DOCUMENT 00 90 00
ADDENDUM

ADDENDUM No.: 4

DATE: March 6, 2025

RE: WESTERN TECHNICAL COLLEGE
AUTOMOTIVE TECHNOLOGY CENTER ADDITION AND REMODEL
2721 LARSON ST.
LA CROSSE, WISCONSIN 54603
PROJECT NO. 24061

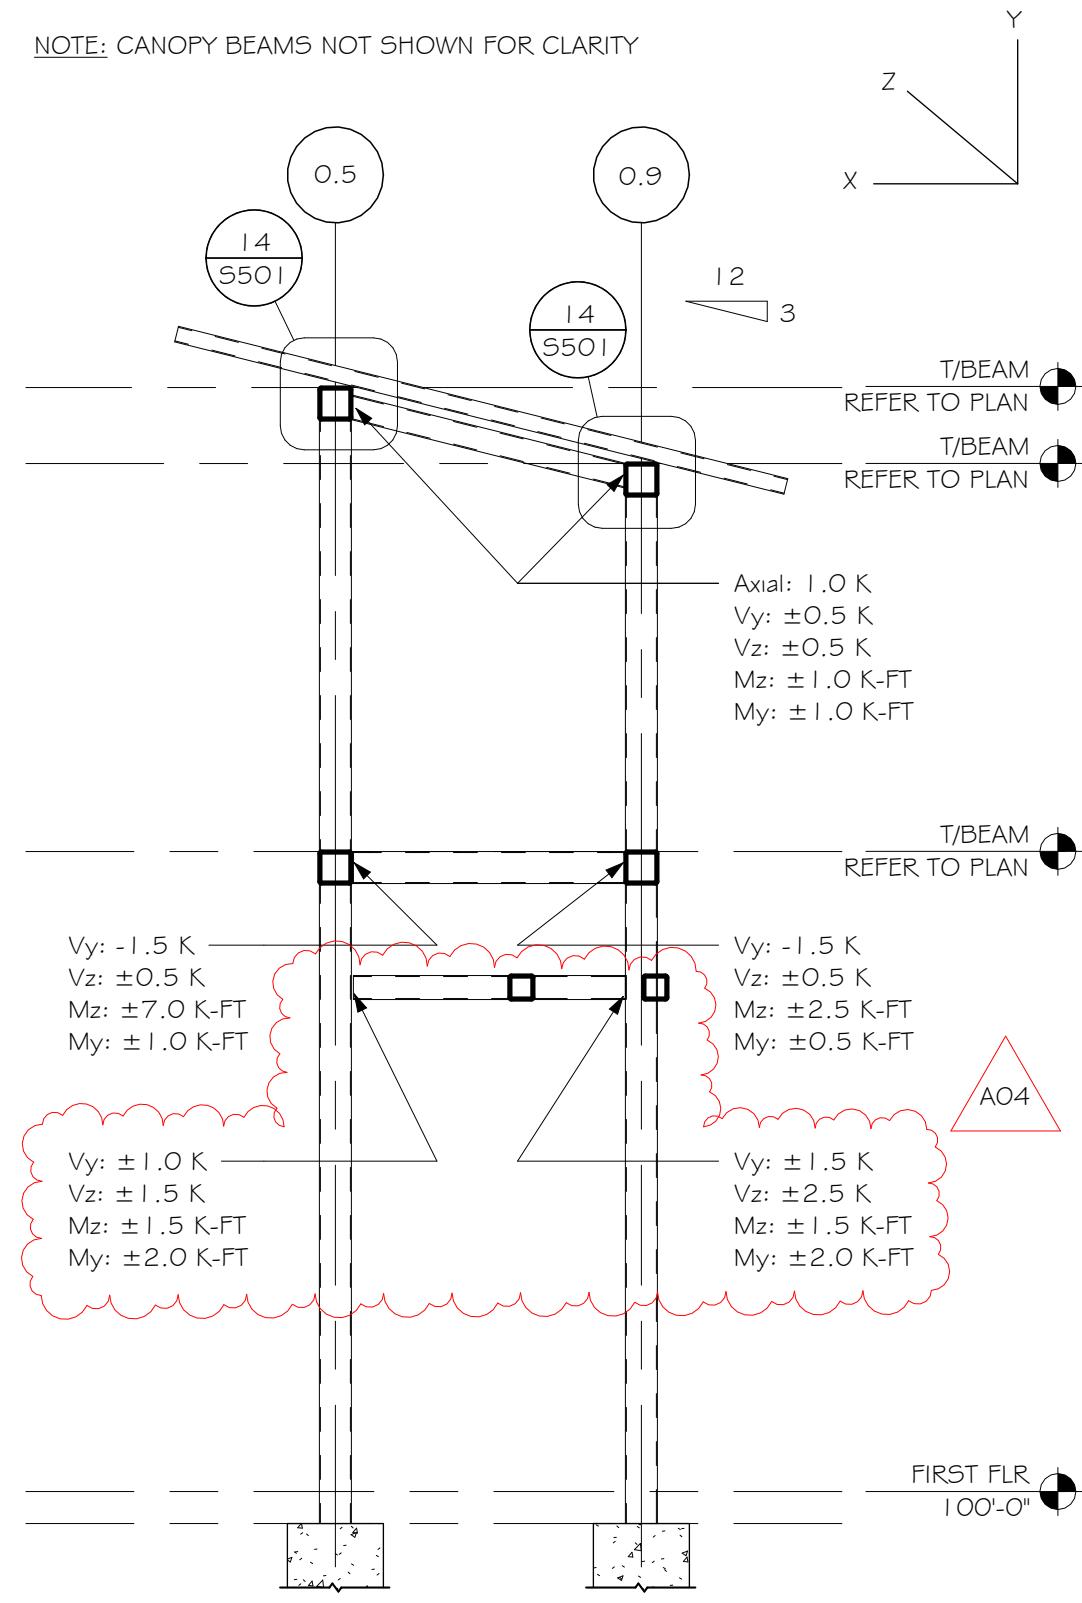
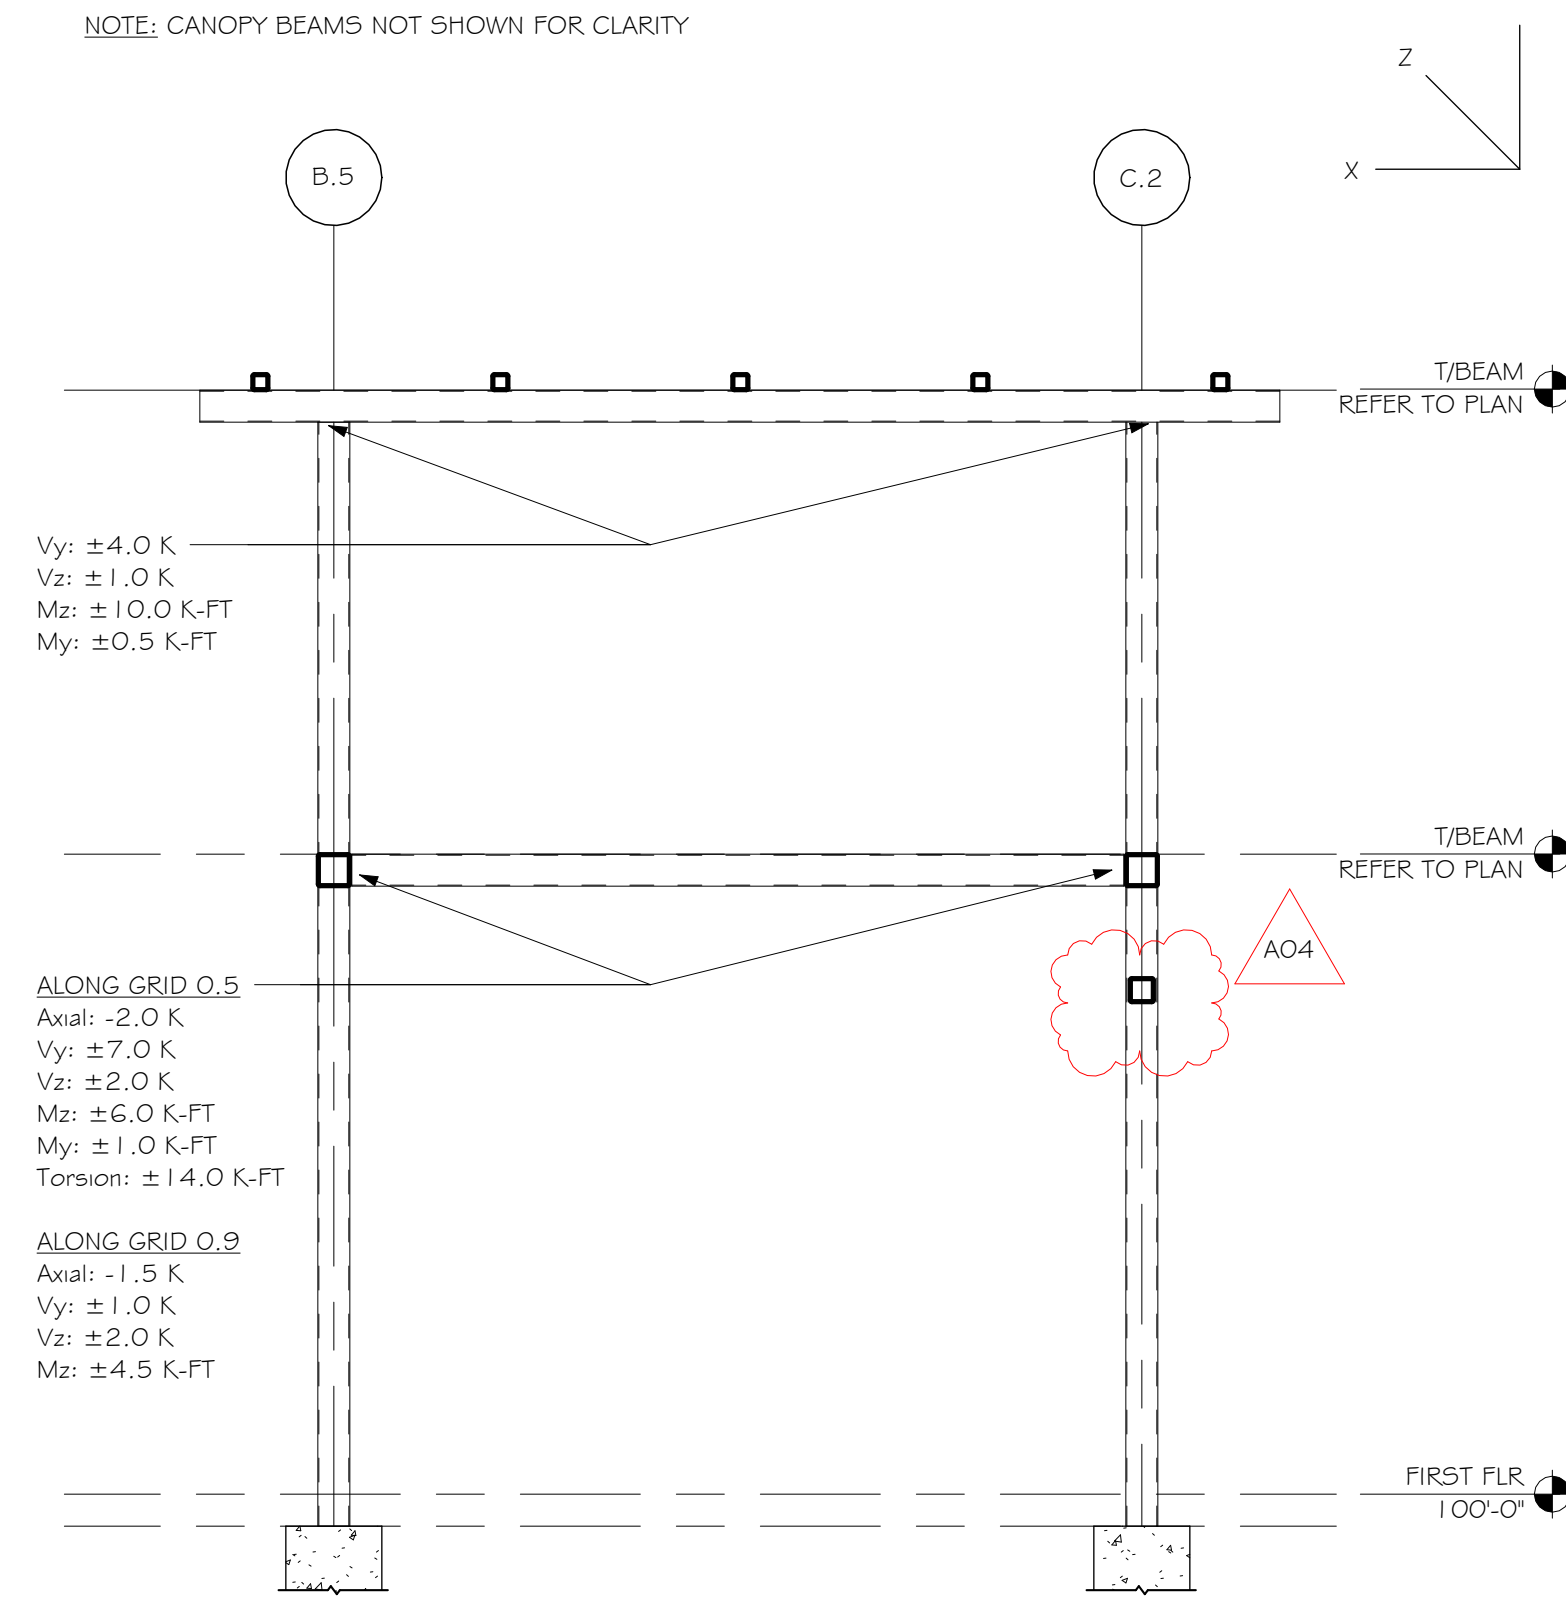
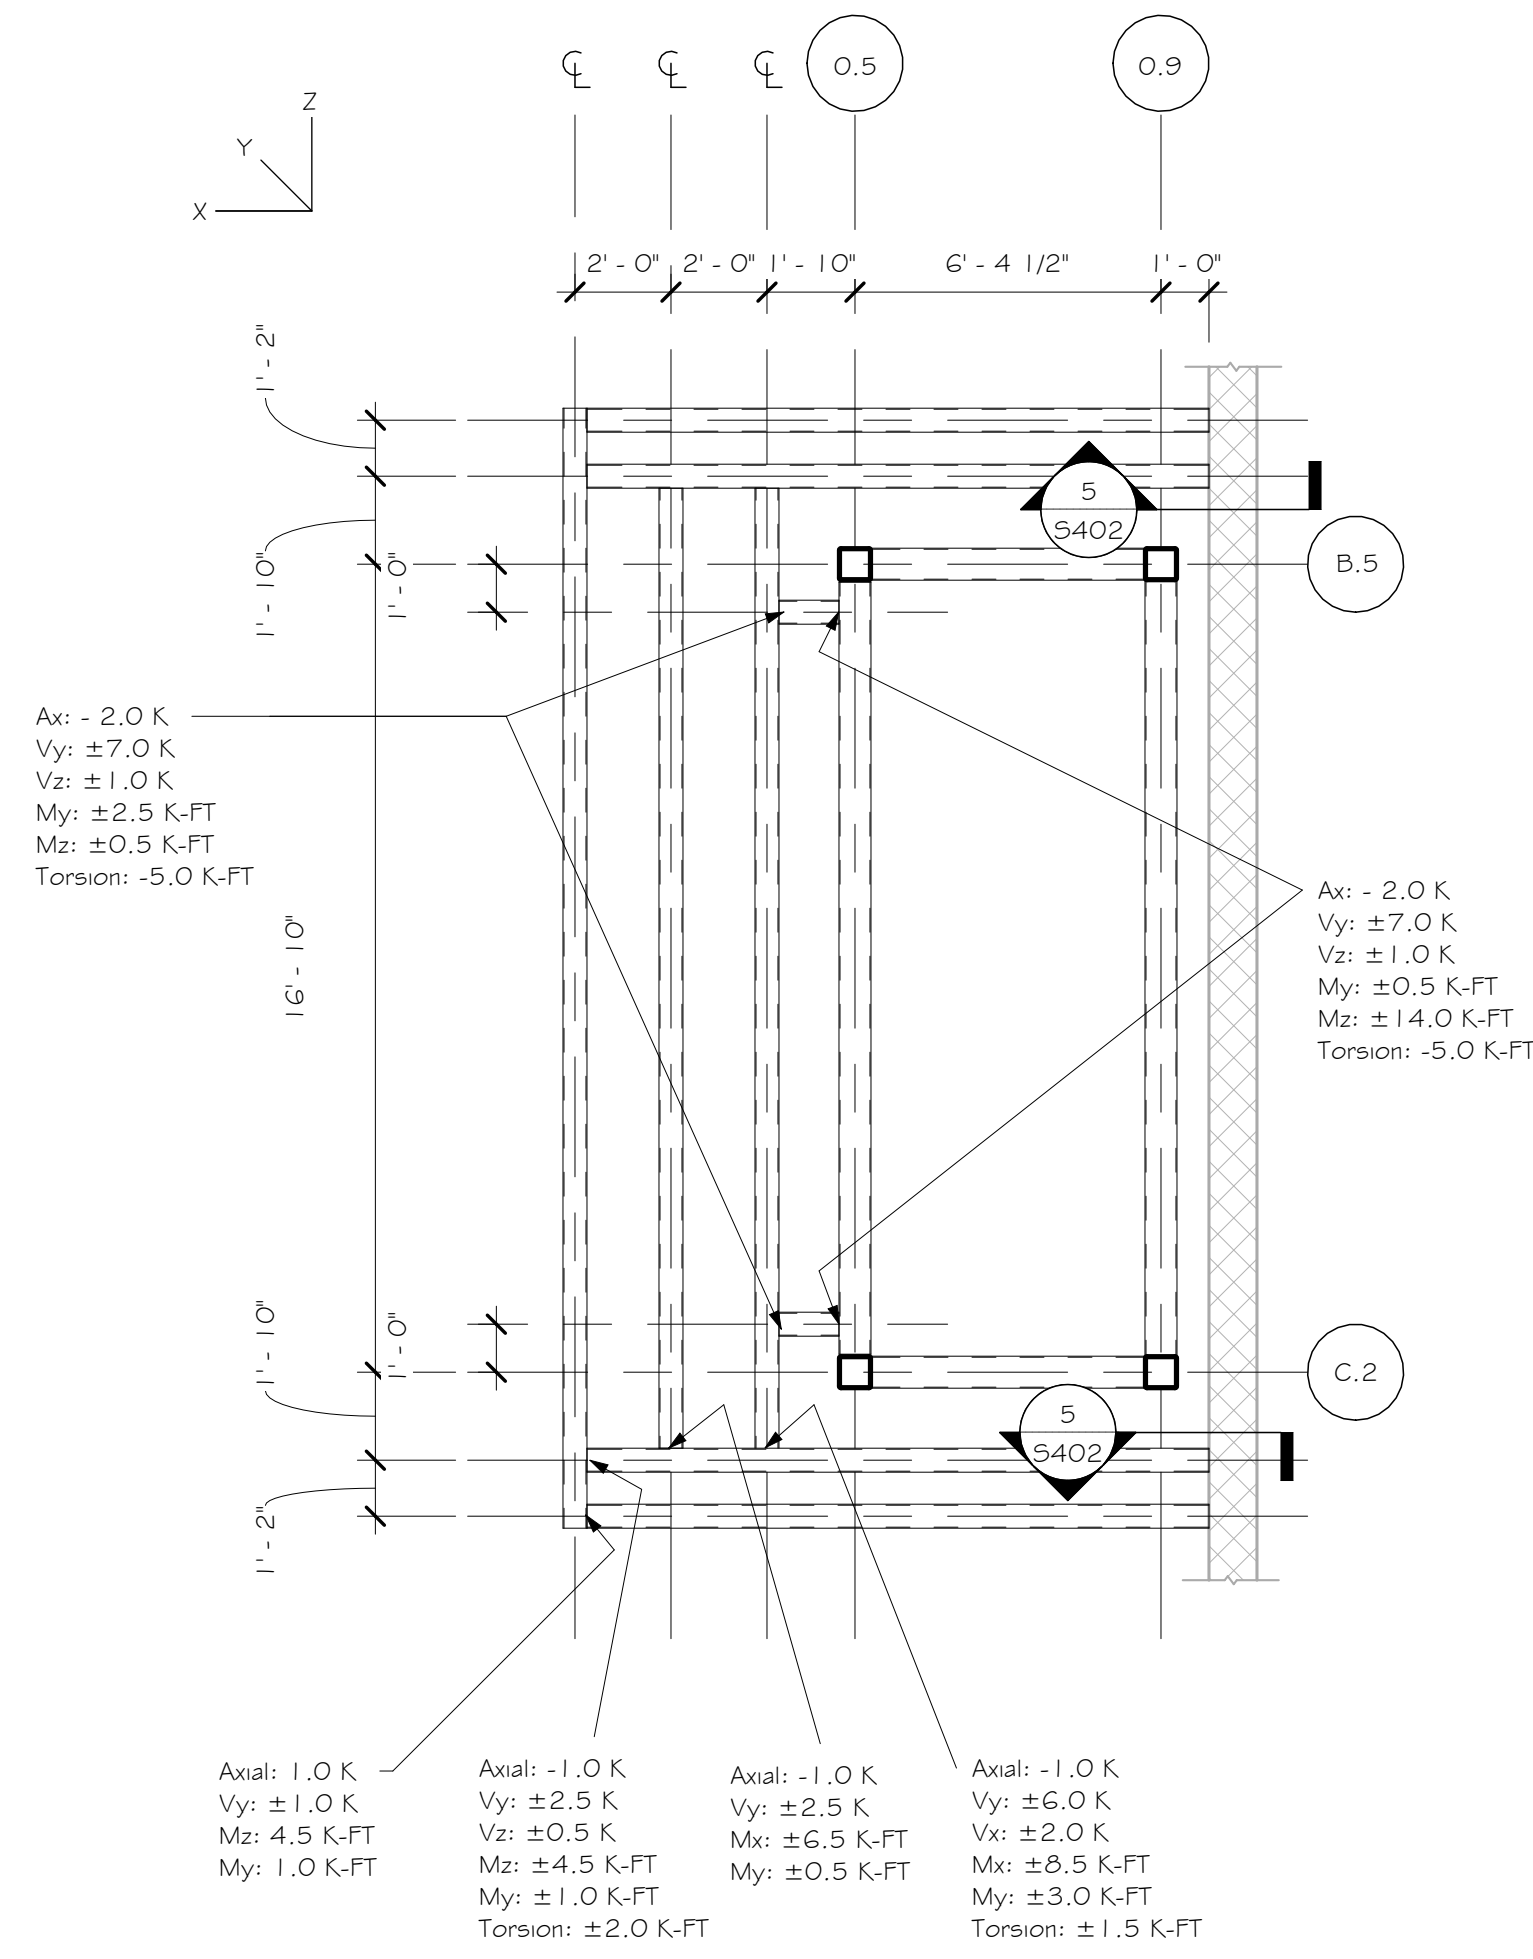
21. Sheet S502 ELEVATION DETAILS 30"x42"
 - a. See the revised sheet included in this addendum. Disregard the previous version.
 - b. Revised framing elevations to add connection between canopy framing and vestibule framing.

NORTH
1 MECHANICAL REMOVAL PLAN - SEGMENT B
1/8" = 1'-0"

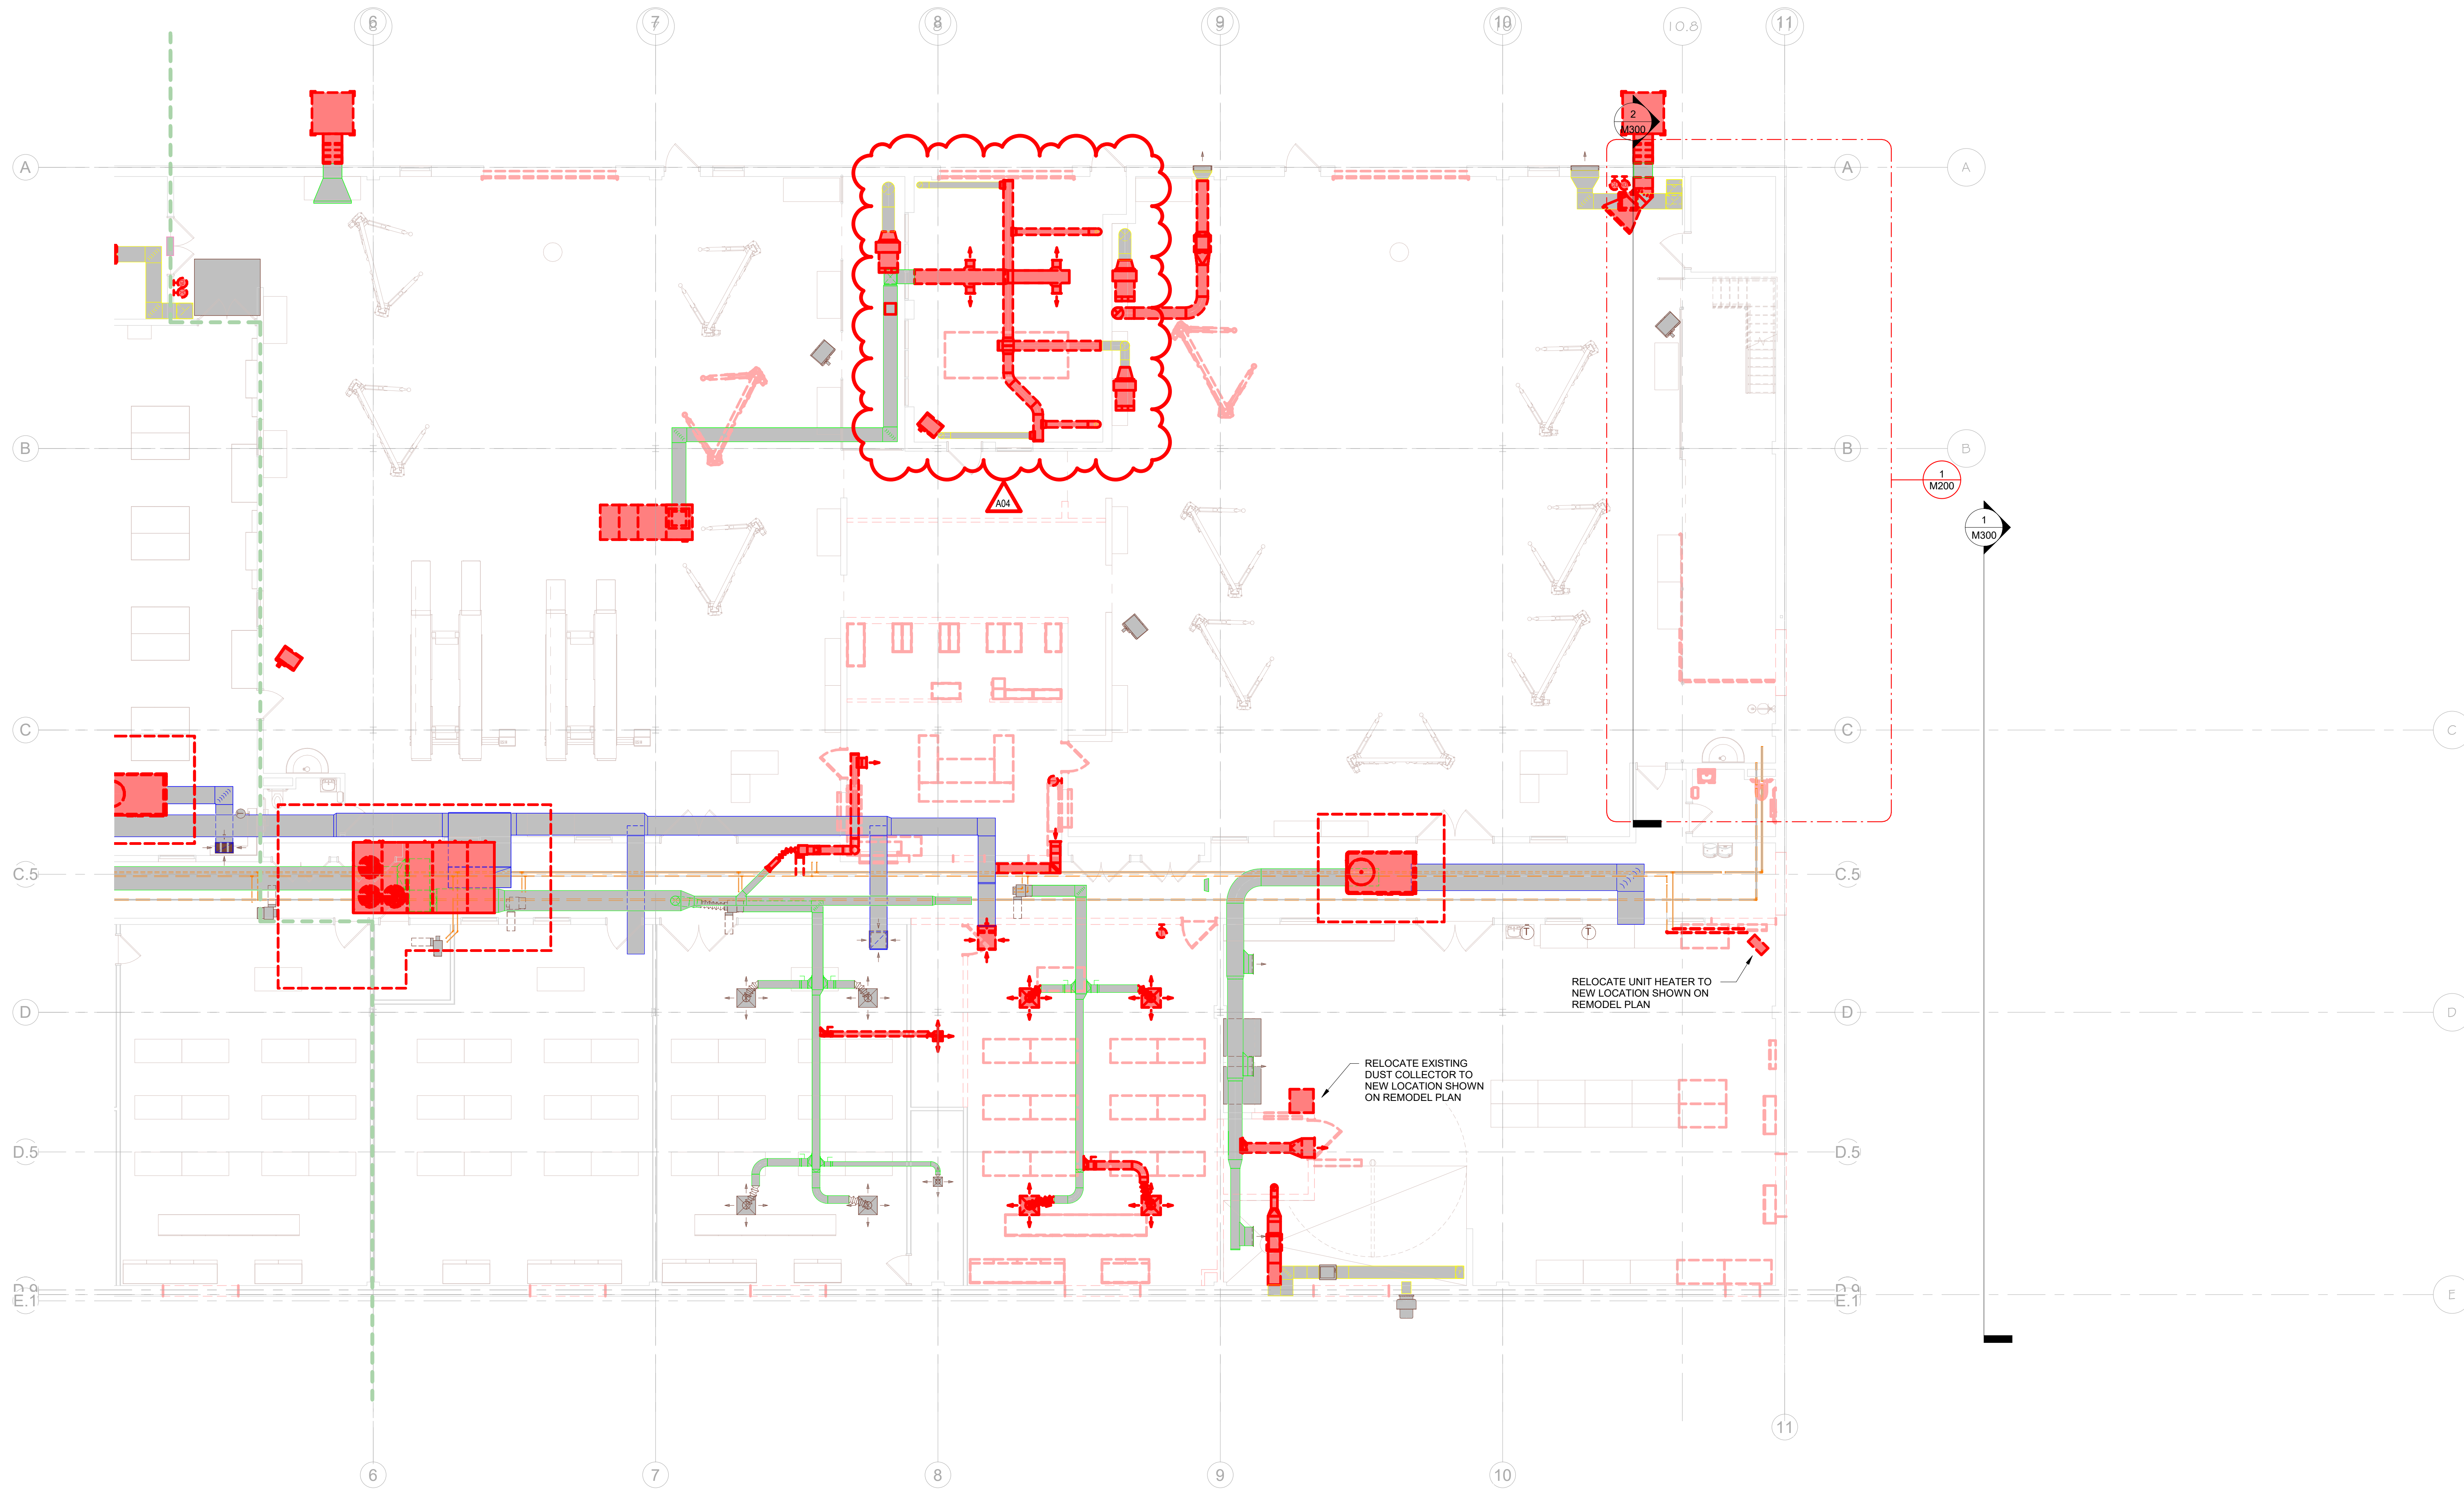
22. Sheet M091 HVAC REMOVAL PLAN – SEGMENT B 30"x42"
 - a. See the revised sheet included in this addendum. Disregard the previous version.
 - b. Add requirement to remove the existing utility blower duct in Tire 151.
